**GEORGETOWN MIDDLE-HIGH SCHOOL RENOVATIONS
Georgetown, MA**

ADDENDUM NO.2

February 13, 2015

D·R·A
 RM2-05
 Ref. Dwg. M1-1-2A

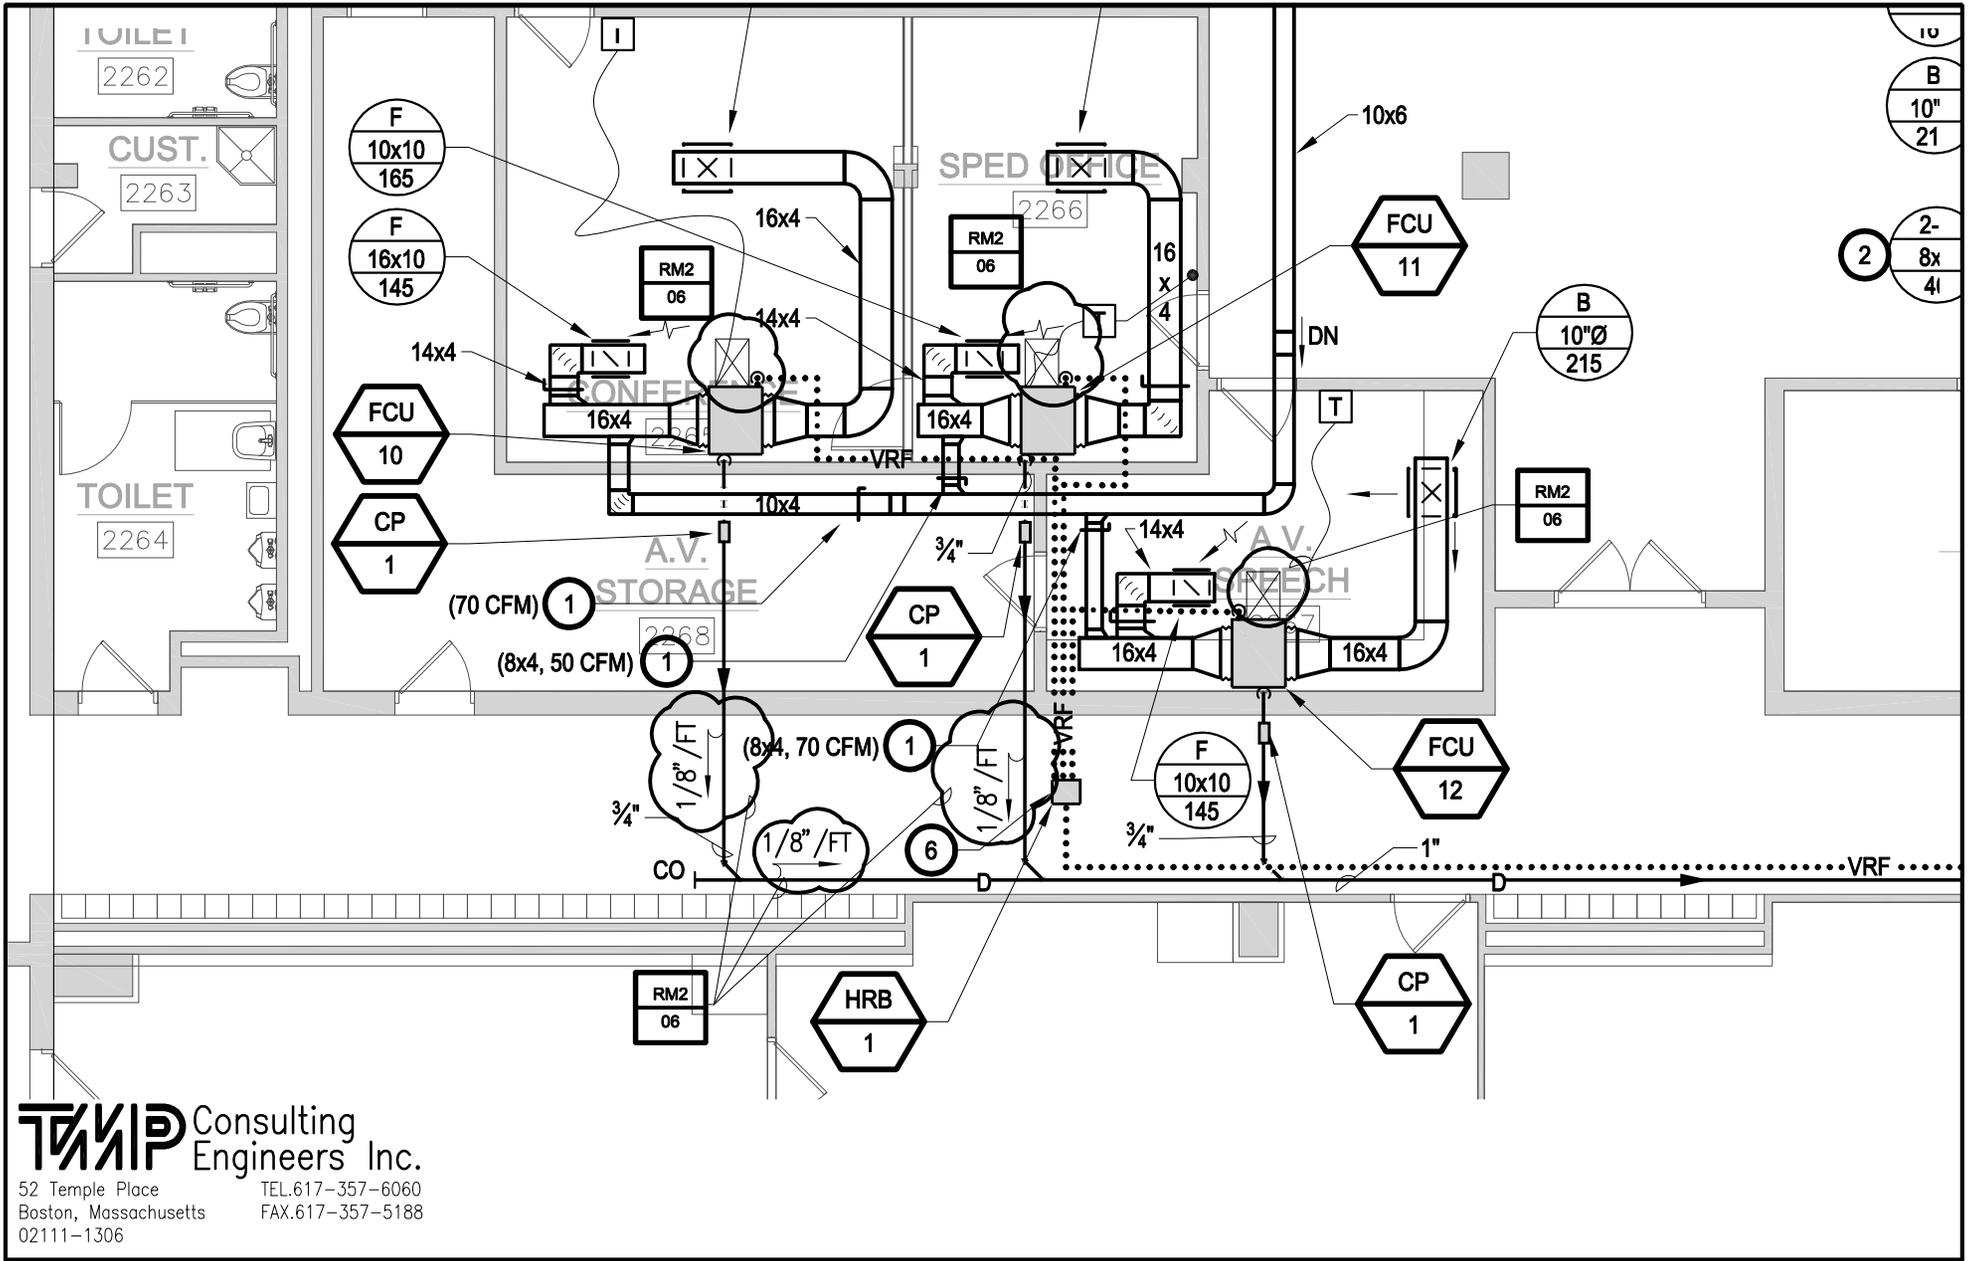
ADD 2-55 M1-1-2A – HVAC SECOND FLOOR PLAN AREA A
ADD drain pitch annotation and equipment access annotation. Refer to attached sketch RM2-05.

D·R·A
 RM2-06
 Ref. Dwg. M1-1-2A

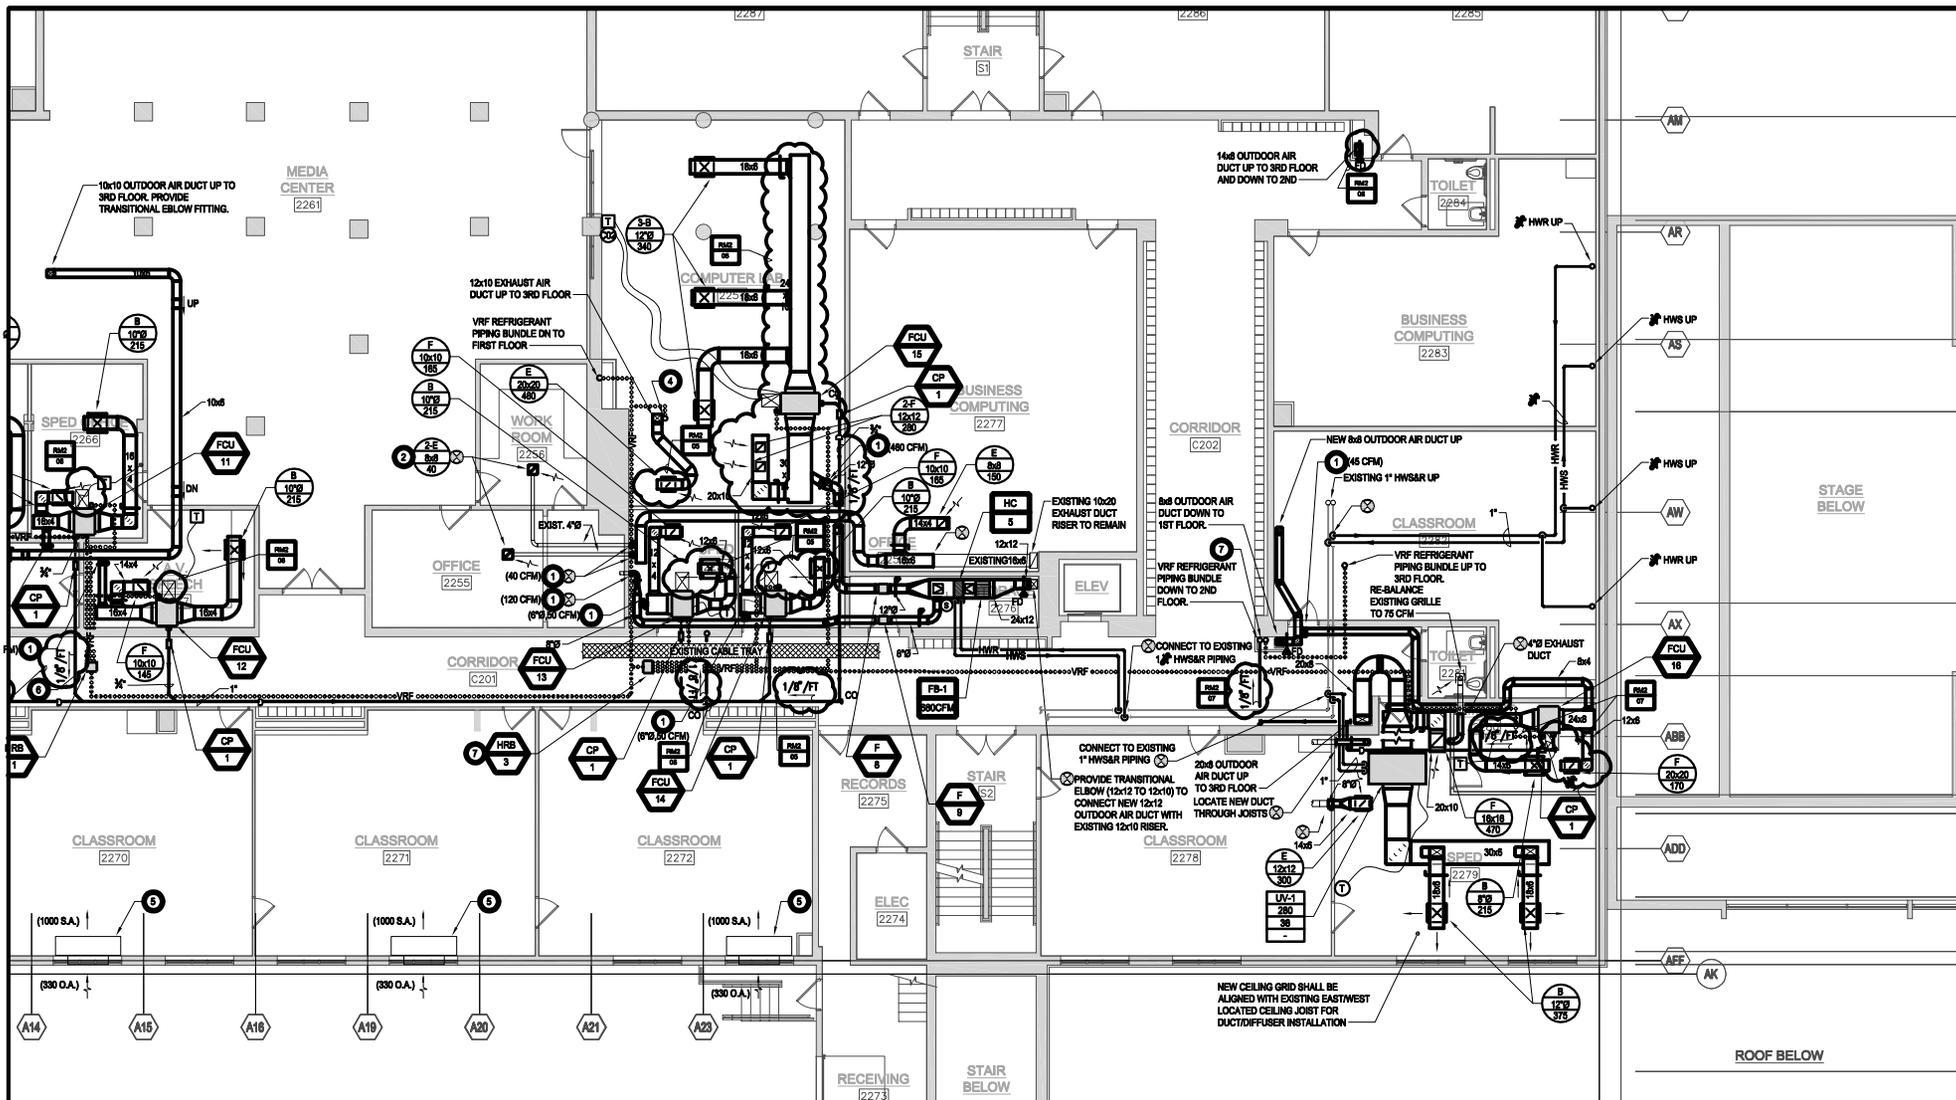
ADD 2-56 M1-1-2A – HVAC SECOND FLOOR PLAN AREA A
ADD drain pitch annotation and equipment access annotation. Refer to attached sketch RM2-06.

RM2-07
 Ref. Dwg. M1-1-2A

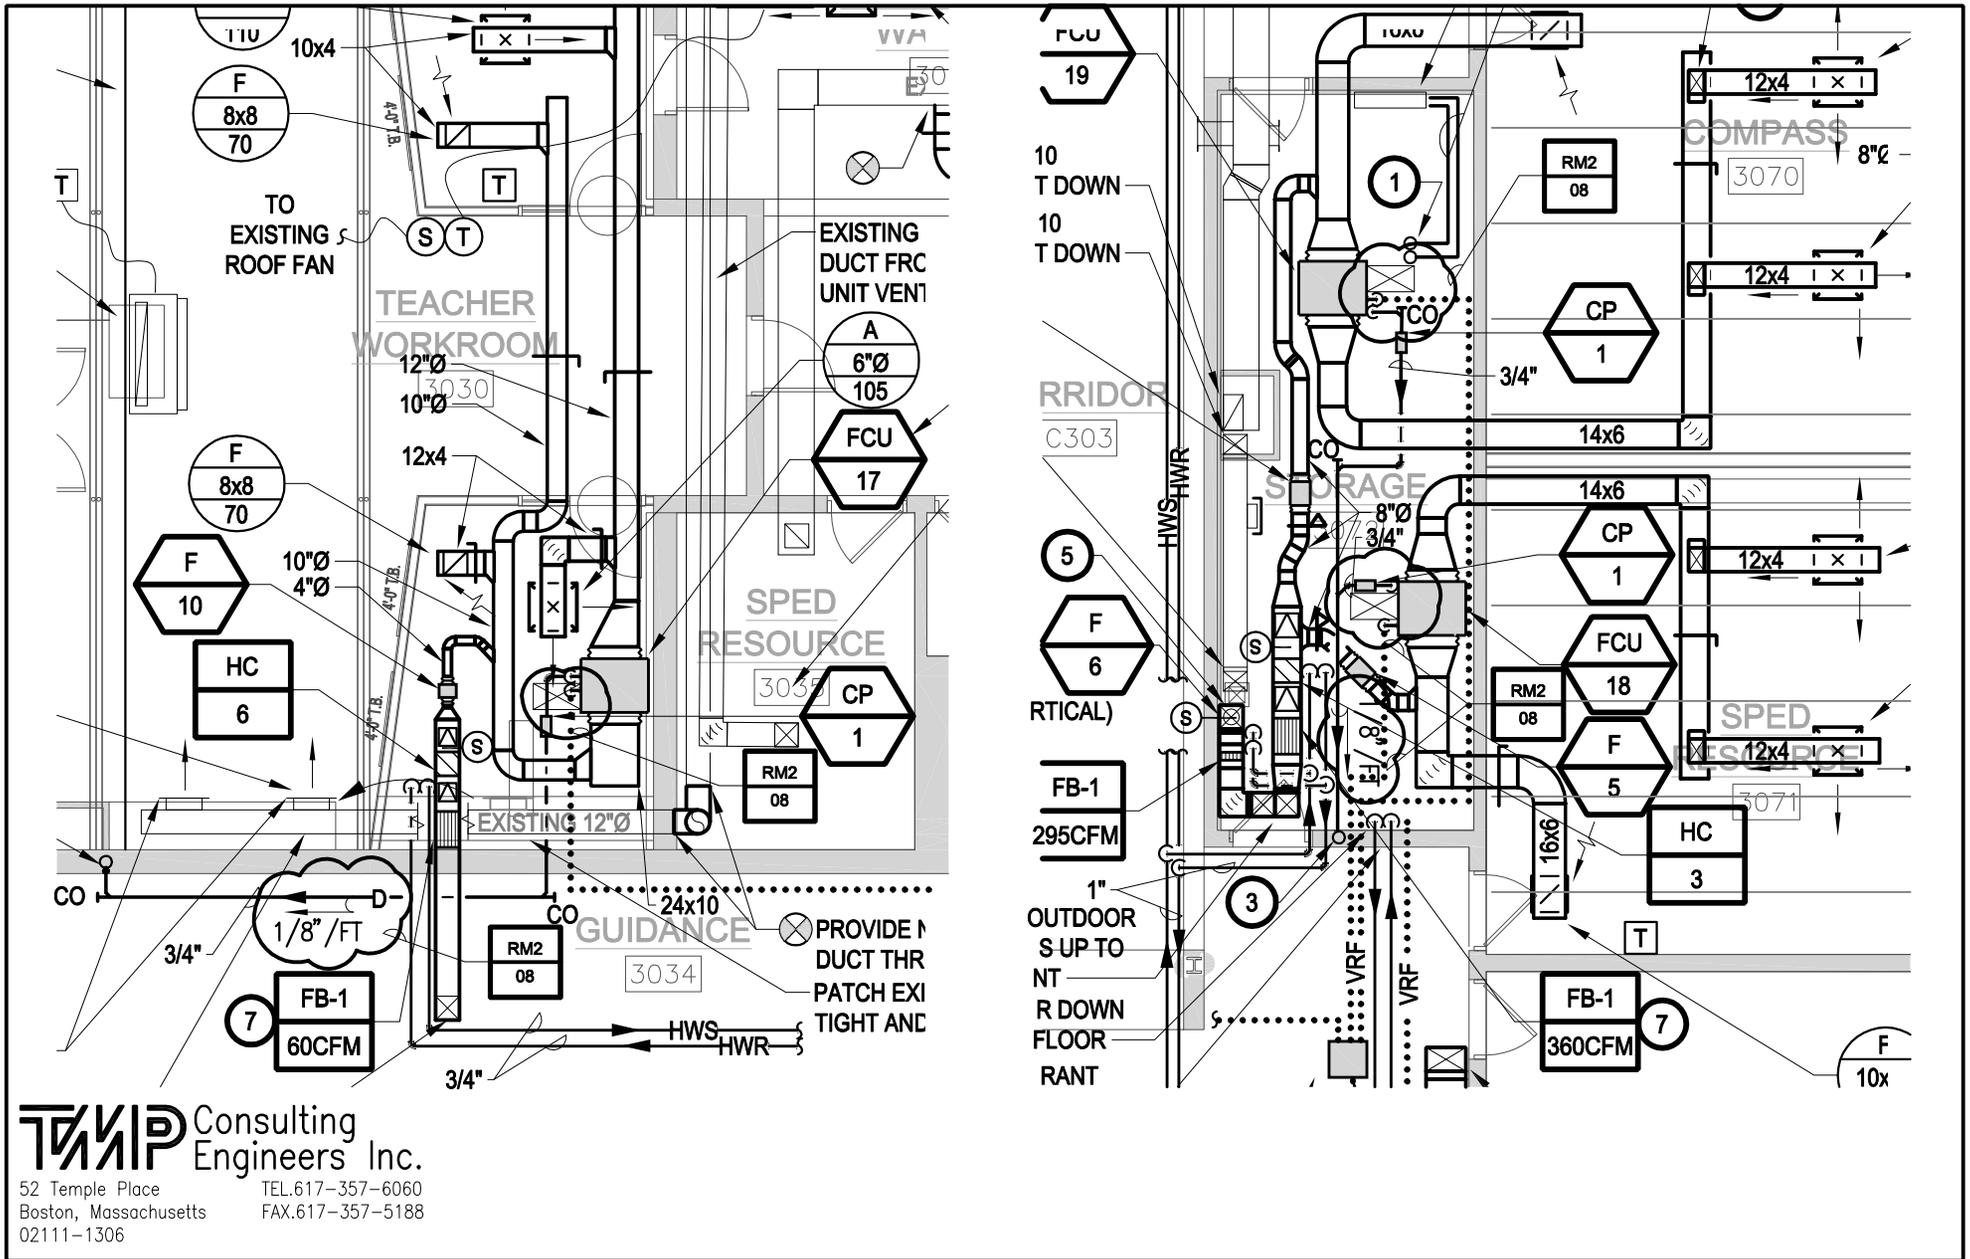
ADD 2-57 M1-1-2A – HVAC SECOND FLOOR PLAN AREA A
ADD drain pitch annotation and equipment access annotation. Refer to attached sketch RM2-07.

D·R·A
 RM2-08
 Ref. Dwg. M1-1-3A

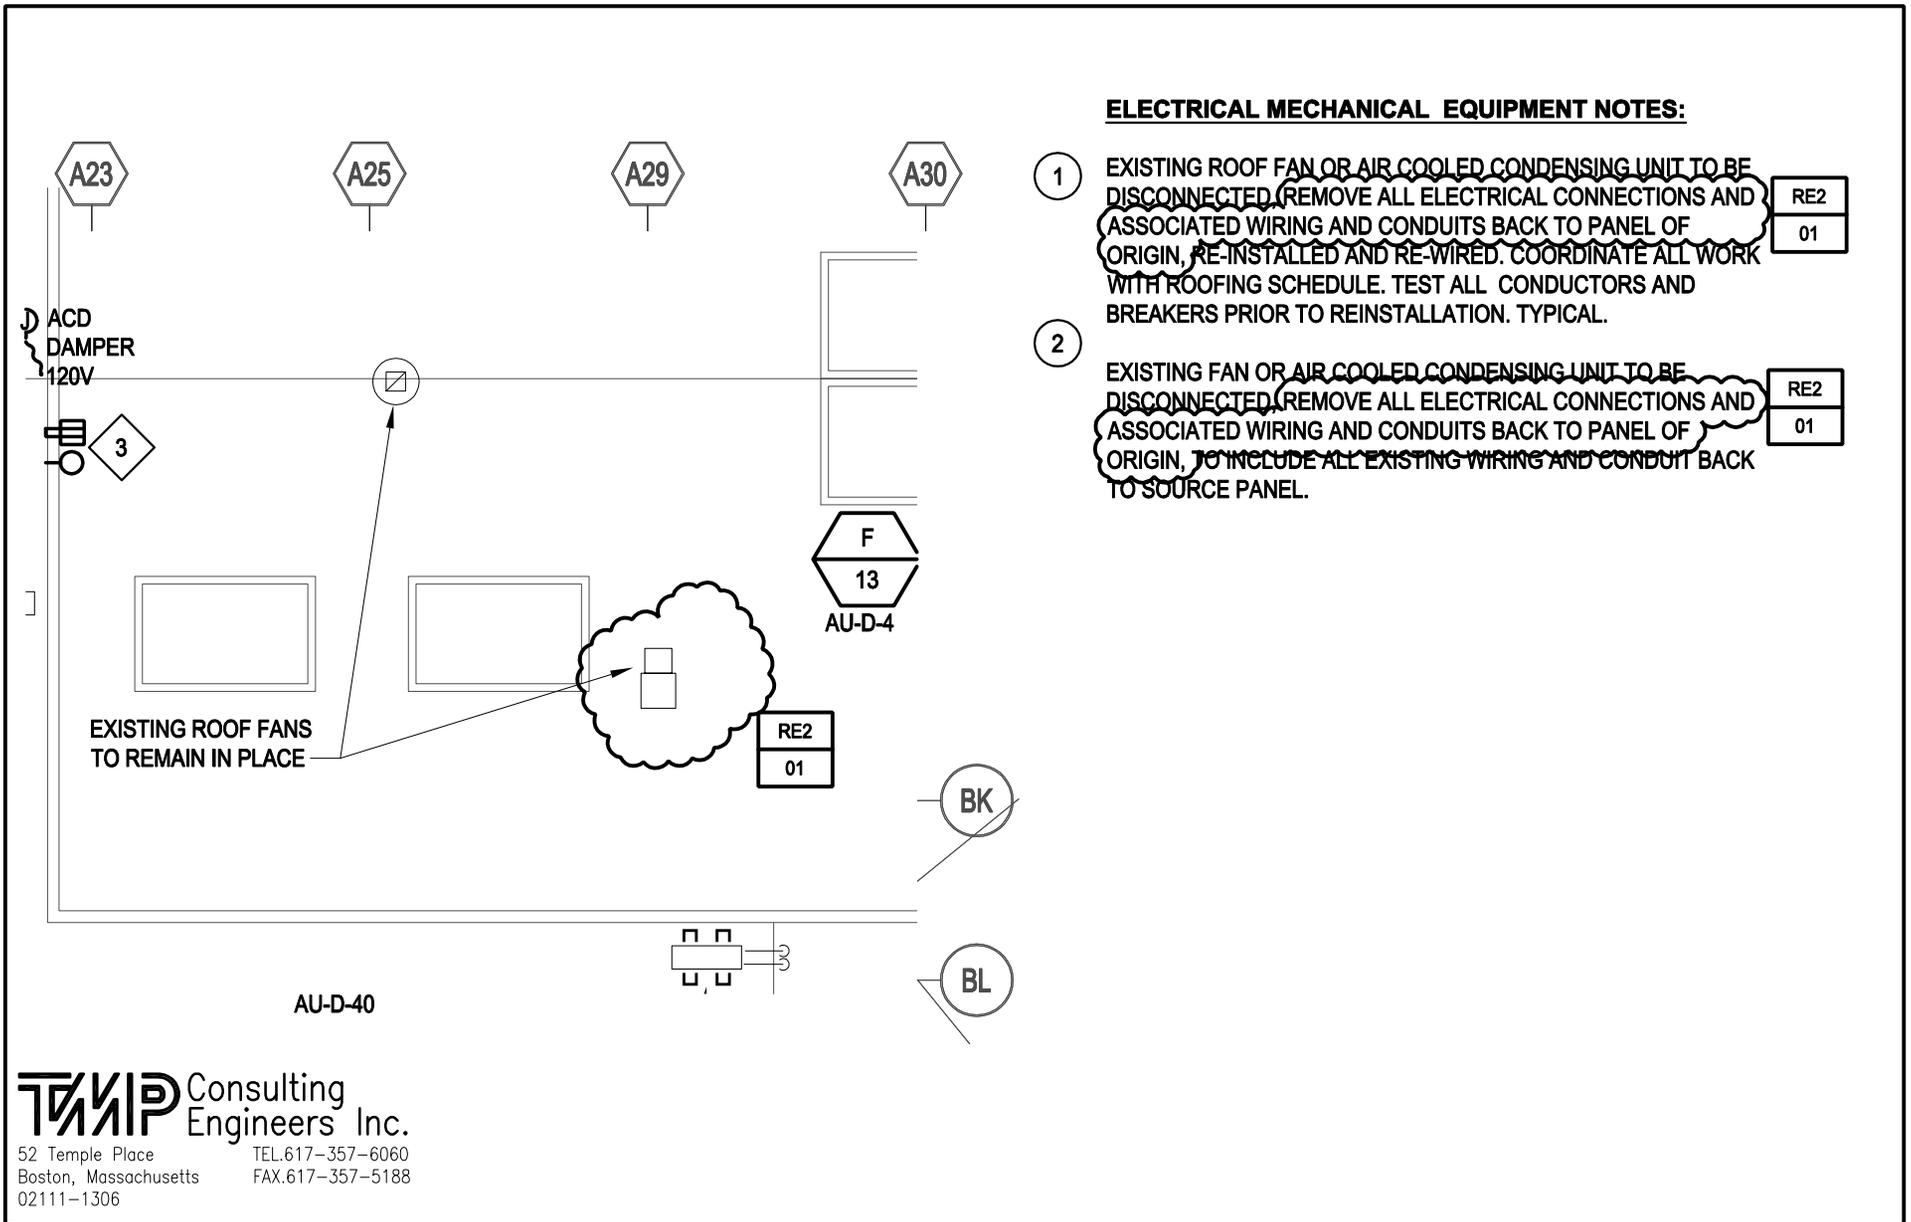
ADD 2-58 M1-1-3A – HVAC THIRD FLOOR PLAN AREA A
ADD drain pitch annotation and equipment access annotation. Refer to attached sketch RM2-08.

RE2-01
 Ref. Dwg. E1-4-4A

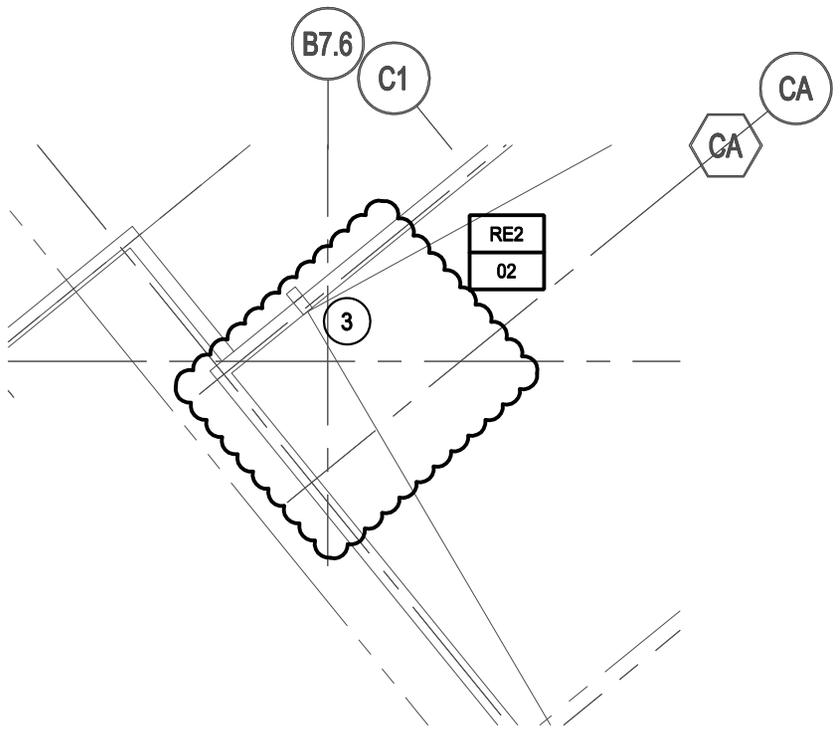
ADD 2-59 E1-4-4A – ELECTRICAL ROOF PLAN AREA A
REVISED notes and DELETED a ley note at existing fan. Refer to attached sketch RE2-01.

- 1 EXISTING ROOF FAN OR AIR COOLED CONDENSING UNIT TO BE DISCONNECTED. REMOVE ALL ELECTRICAL CONNECTIONS AND ASSOCIATED WIRING AND CONDUITS BACK TO PANEL OF ORIGIN, RE-INSTALLED AND RE-WIRED. COORDINATE ALL WORK WITH ROOFING SCHEDULE. TEST ALL CONDUCTORS AND BREAKERS PRIOR TO REINSTALLATION. TYPICAL. RE2
01
- 2 EXISTING FAN OR AIR COOLED CONDENSING UNIT TO BE DISCONNECTED. REMOVE ALL ELECTRICAL CONNECTIONS AND ASSOCIATED WIRING AND CONDUITS BACK TO PANEL OF ORIGIN, TO INCLUDE ALL EXISTING WIRING AND CONDUIT BACK TO SOURCE PANEL. RE2
01

RE2-02
 Ref. Dwg. E1-4-4BC

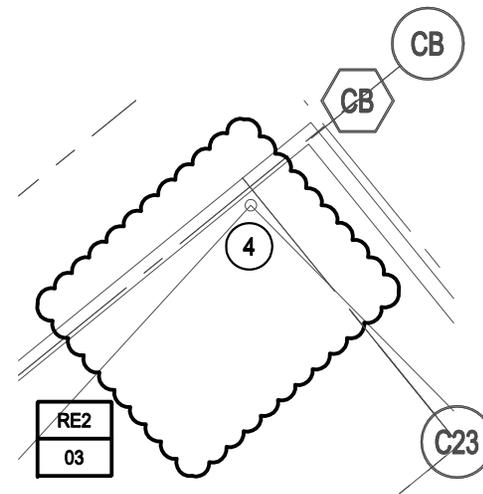
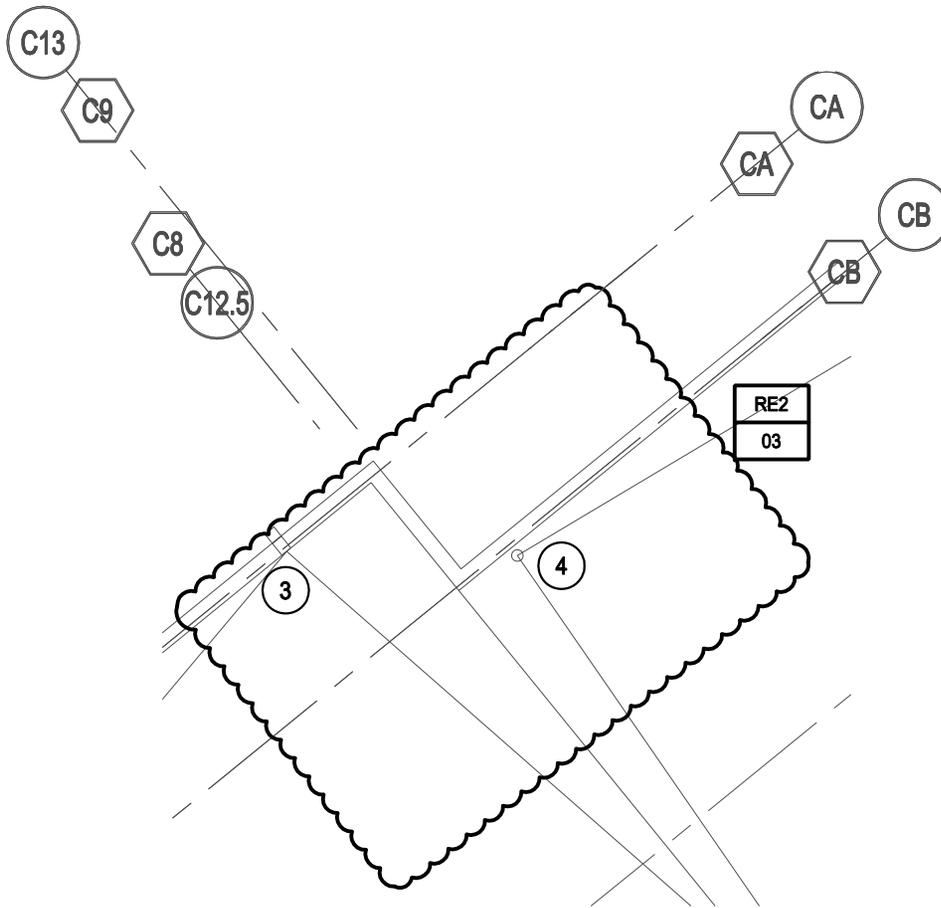
ADD 2-60 E1-4-4BC – ELECTRICAL ROOF PLAN AREAS B AND C
ADDED heat trace at Alternate Gym Room 2291 and Gymnasium Room 2293. ADDED heat trace note. Refer to attached sketches RE2-02 and RE2-03.

3 INTERCEPT, EXTEND AND RECONNECT EXISTING 120V BRANCH CIRCUIT SERVING CONVENIENCE OUTLETS IN ALTERNATE GYM RM 2291 TO HEAT TRACE SYSTEM. PROVIDE ALL REQUIRED INTERCONNECTIONS FOR CONTROLS AND POWER FOR A COMPLETE SYSTEM.
